Project Name: Pearl Fire Stations

Project Number: 22-099 & 22-108

ADDENDUM NO. 03

1 FOUNDATION PLAN
1/8" = 1'-0"

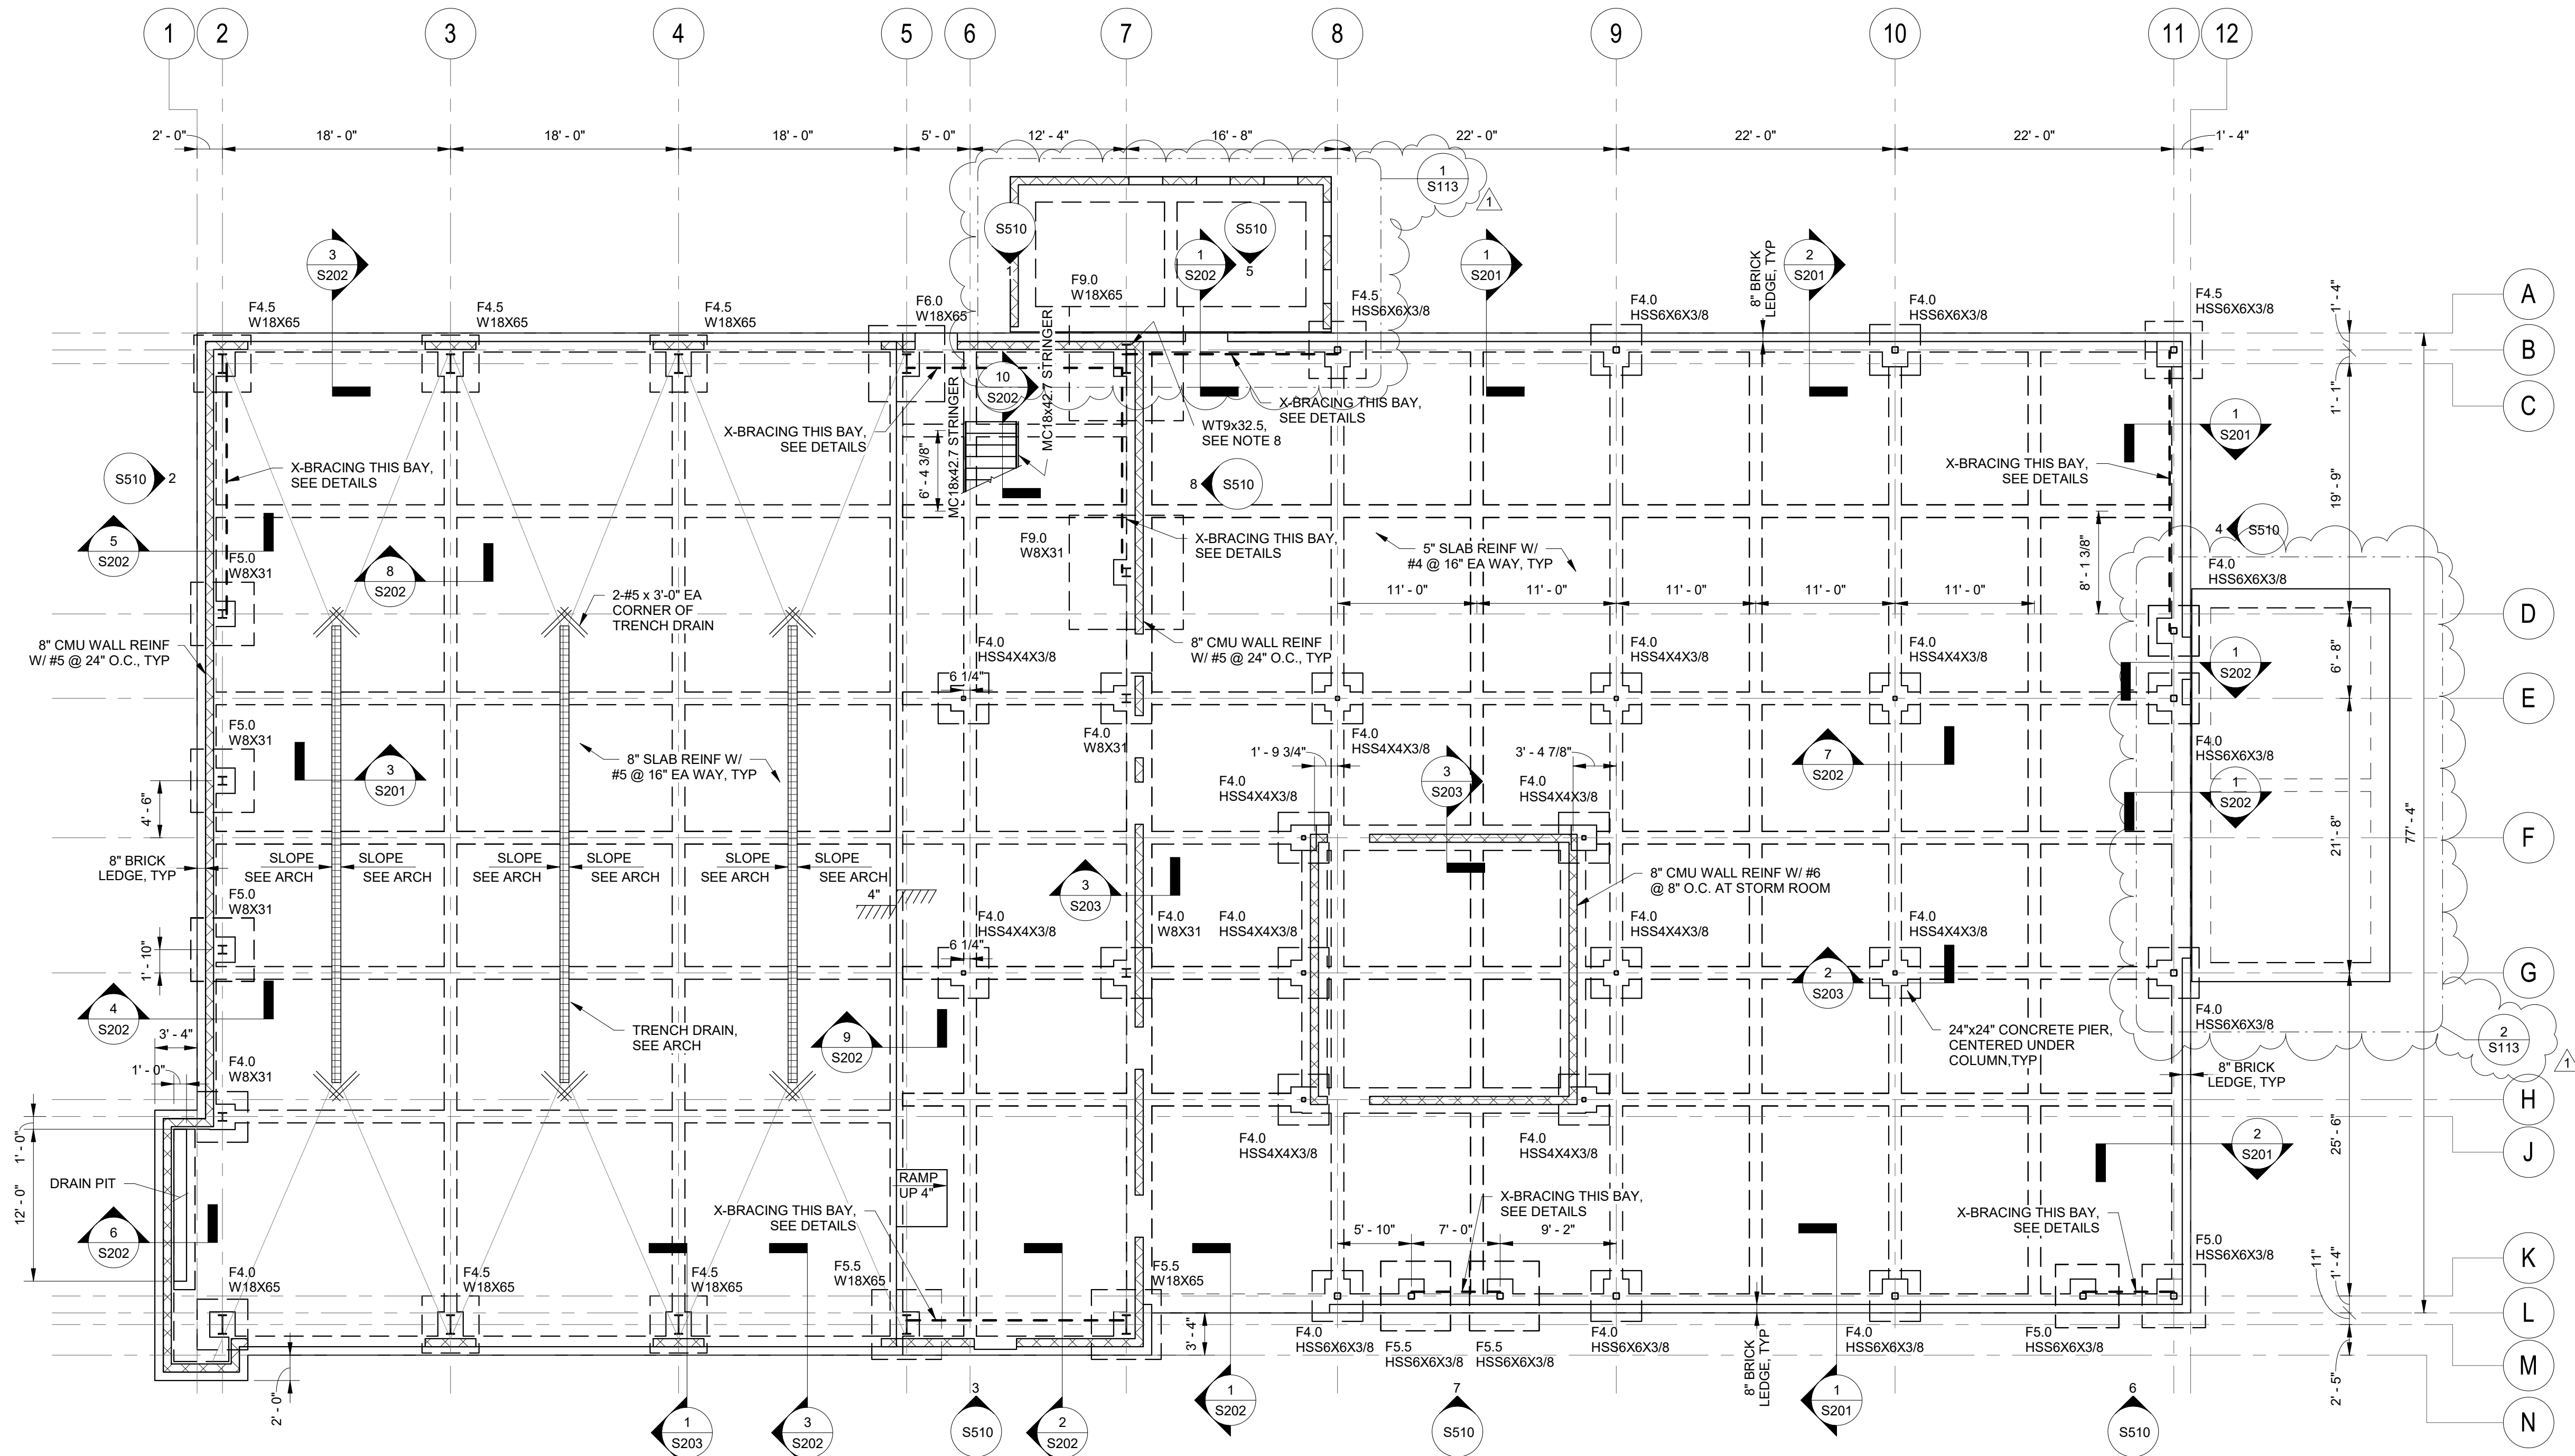
- ITEM NO. 10 **S110 Foundation Plan - Central Station**
REPLACE Sheet S110 with the attached **Revised Sheet S110**.
Clarification: Sheet revisions include foundation/slab information for patio slab and mechanical yard slab.
